## **Addendum to representation by Brockham Oil Watch**

**(Surrey County Council Planning Application MO/2018/0444 / SCC ref 2017/0215  
Brockham Wellsite, Felton's Farm, Old School Lane, Brockham, Surrey RH3 7AU)**

**David K. Smythe**

**8 May 2018**

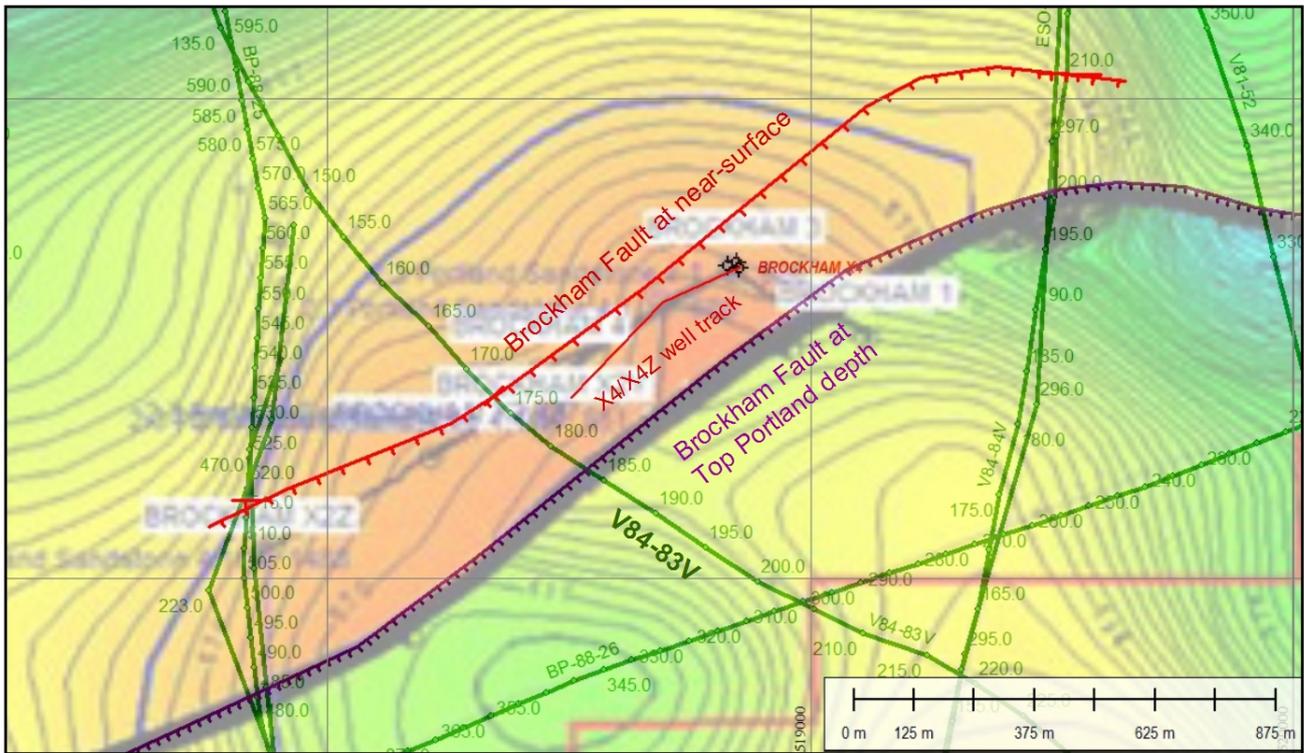
More fundamentally, the existing database is not sufficiently robust to define the geological structures in sufficient detail. Figure 1 shows contours in depth of the Top Portland, coloured so that yellow through orange indicates a structural high, and green through blue indicates a low. The database for the contouring comprises the seismic lines shown in green, plus the group of wells drilled at Brockham in the upper-central part of the figure. The structure is a tilted block, faulted along its SE flank by what I call the Brockham Fault.

The wells lie within the zone of the fault. The structure is constructed by interpolation, between two or three coincident N-S trending seismic lines on the west, through line V84-83V running NW-SE through the centre, and a pair of N-S line in the east. A tie-line shown running WSW-ENE at the bottom of the figure is somewhat inadequate as it lies on the downthrown side of the Brockham Fault.

No explanation has been offered as to why the south-westerly direction was chosen for the sidetrack well X4Z. The coverage of seismic data dates from 1984 or earlier. Reprocessing can only make marginal improvements to such vintage 2D data. Such coverage was barely adequate even in the era of drilling vertical wells, such as the Brockham-1 discovery well drilled by BP in 1987.

Figure 2. Vertical section running E-W showing the various Brockham wells (no vertical exaggeration). The inset is a plan view.

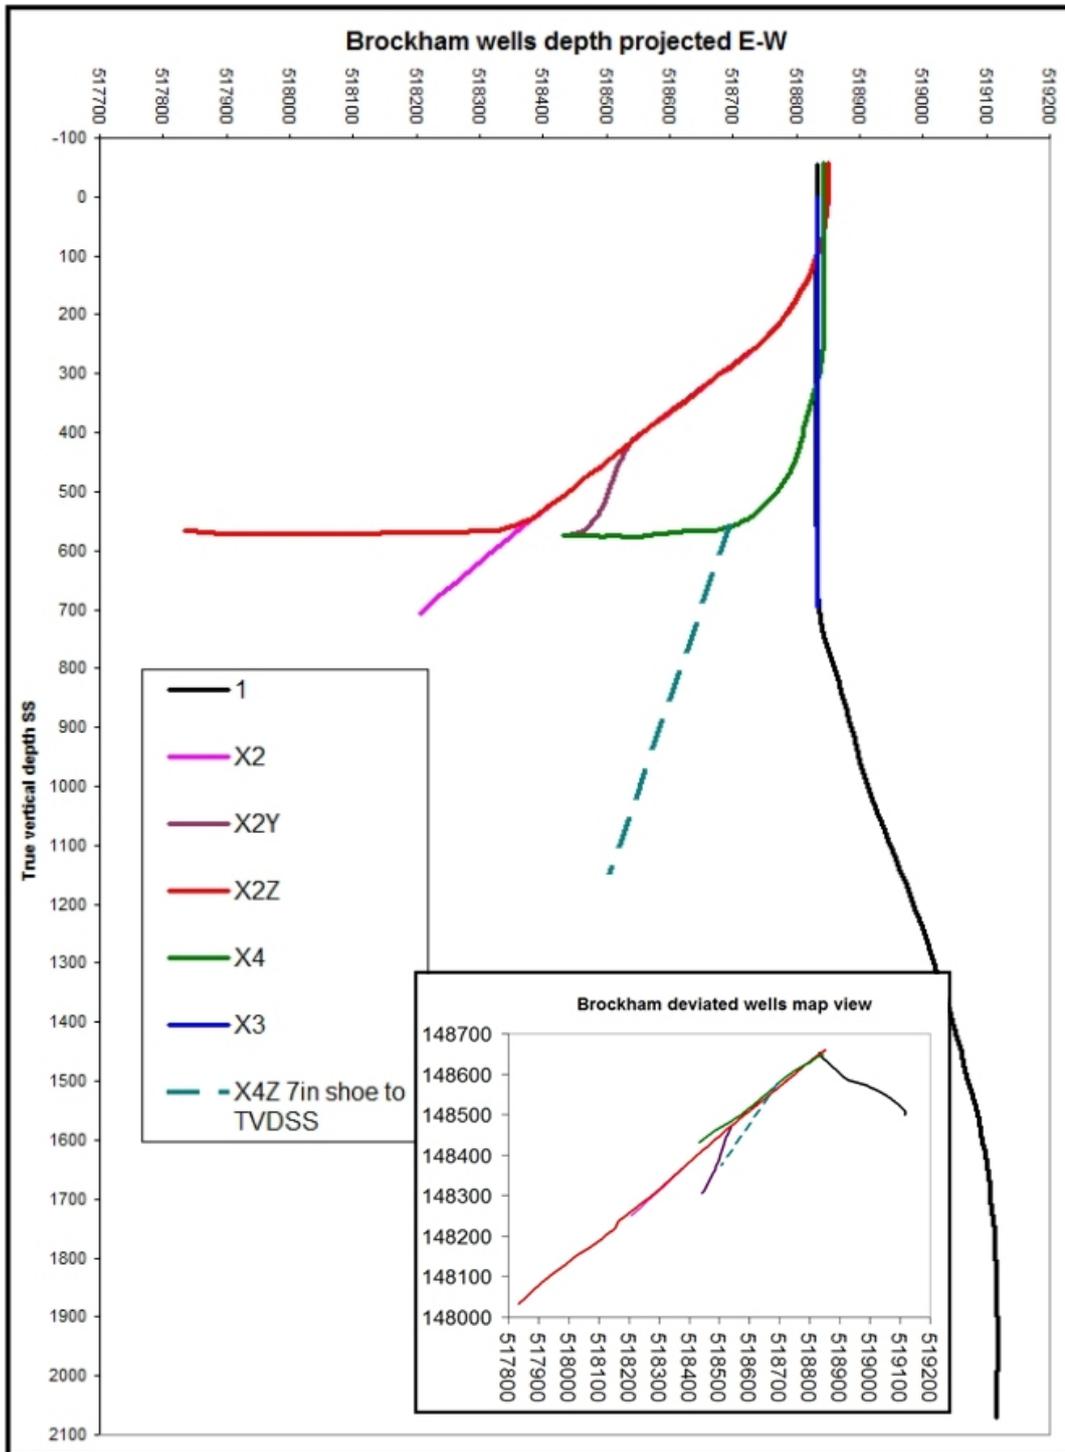
Figure 2 shows the various Brockham wells projected onto an E-W vertical plane, with a plan view shown as an inset. The scales are true (no vertical or horizontal exaggeration). The original BP well, Brockham-1, is depicted by the black line. Although it is slightly deviated to the SE, it is an essentially vertical well. The sidetrack X4Z is shown as a dashed green line coming off the donor well X4 at the 7 inch shoe; the welltrack will be curved as seen in the vertical section, but since only this point and the final point are available for plotting, it is depicted here as a straight line.

Figure 2 shows wells X2Z and X4 turning horizontal in a southwesterly direction along the Portland Sandstone at a depth of just under 600 m below sea level. The sidetrack X4Z takes a more southerly azimuth and turns vertical with increasing depth. It is likely to penetrate the Kimmeridgian micrites within 100 m or so of the adjacent Brockham Fault to the SE.

Figure 3. Seismic section V84-83V (original version, courtesy of the UK Onshore Geophysical Library) showing the Applicant's interpreted faults (red) and the Brockham-X4/X4Z well projected SW, from 550 m NE (near surface) to 100 m NE of the seismic section at the well bottom.

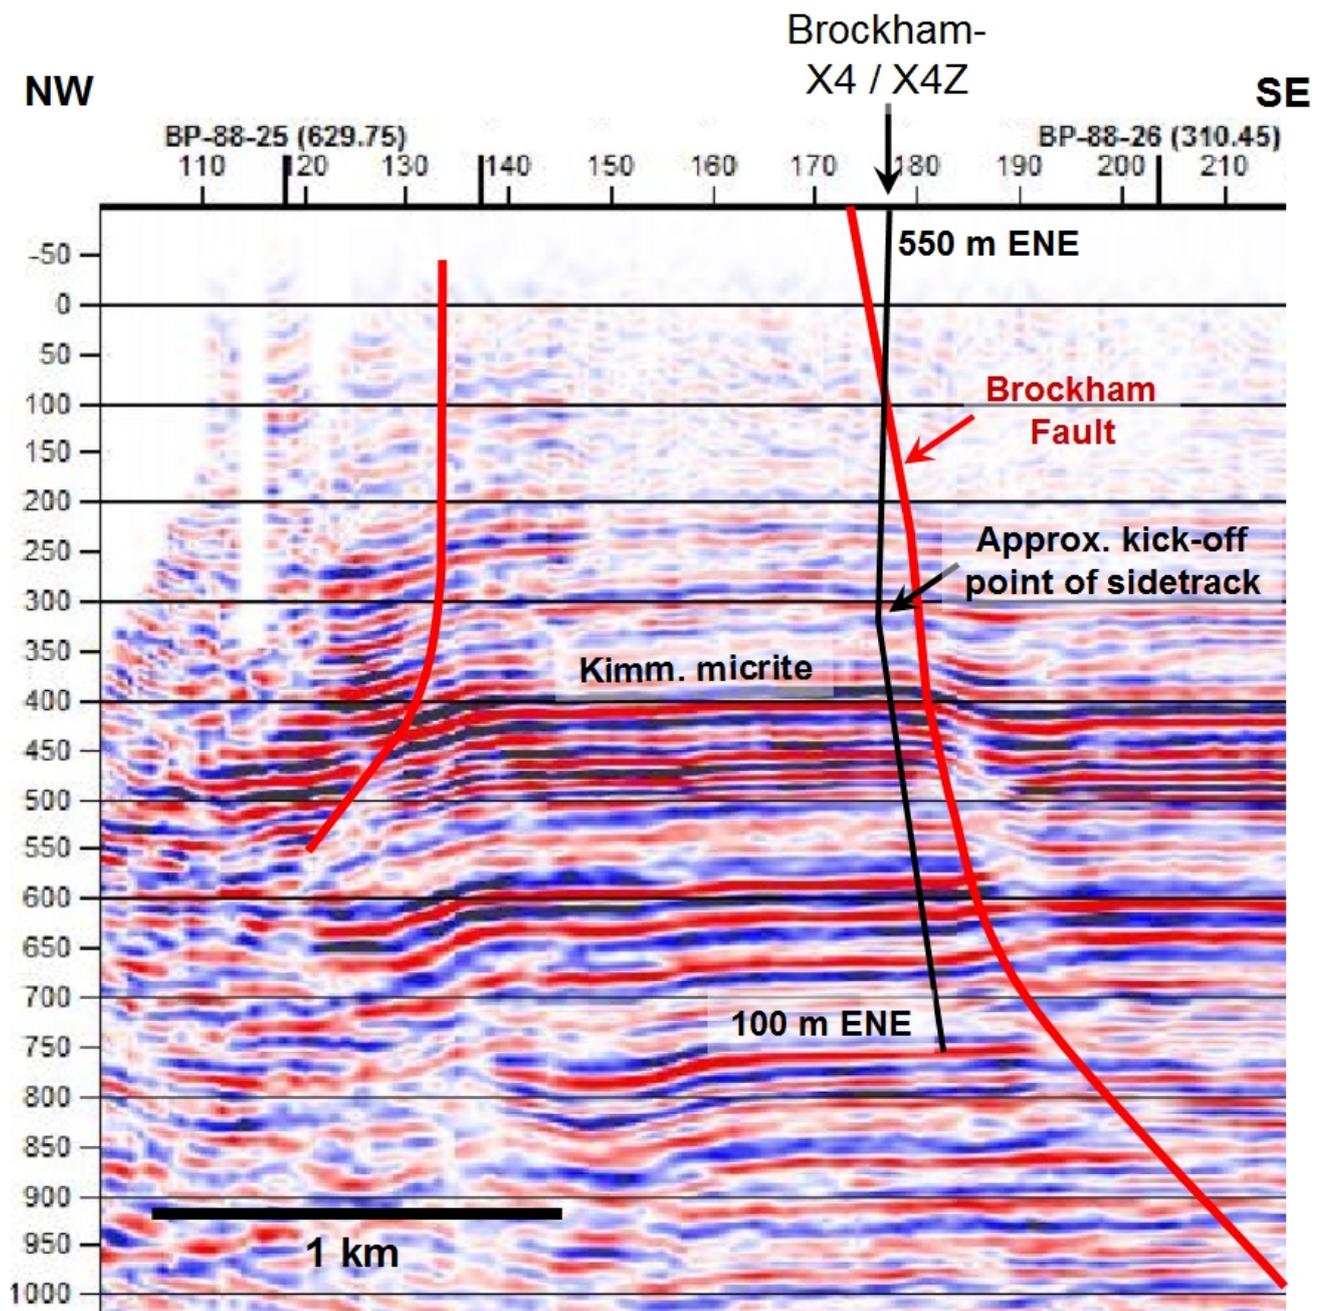
Figure 3 shows a portion of the original version of seismic line V84-83V. I have not used the reprocessed version, available in figure 5.6 of the Exodus report, because the quality of reproduction of the latter is poor. However, there appears to be no significant difference between the two

The principal fault of interest is the field-bounding fault downthrowing to the south. I have marked the approximate location of Brockham-X4 (the donor well) and its sidetrack X4Z on the map of Figure 1, projected SW (at an azimuth of 232°) onto the plane of the seismic section of Figure 3. The projection distance is 550 m at or near the surface, diminishing to about 100 m at the bottom of the

The final depth of the well is shown only approximately in Figure 3 because the vertical scale of the seismic section is in two-way travel time, not depth. Interconversion between these two scales requires a knowledge of the velocity-depth profile, which has not been made available.

The well penetrates the Brockham Fault at a shallow depth, and after slight deviations it ends at around 200 m from the fault, but within about 100 m of the fault at the micrite level. There it may therefore lie within the damage zone of the fault - the zone on either side of which the surrounding rock is fractured. This may be intentional on the part of the Applicant, because vertically upwards from the micrites, along the northern flank of the fault, there will be a zone of fracturing which will enhance oil flow. My [analysis](#) of the nearby Horse Hill-1 so-called Kimmeridgian 'discovery' by UK Oil & Gas Ltd (the 'Gatwick Gusher') shows that the reason for the temporary high oil flow at Horse Hill-1 was probably because the well was drilled about 60 m north of a fault, and well within the damage zone of that fault.
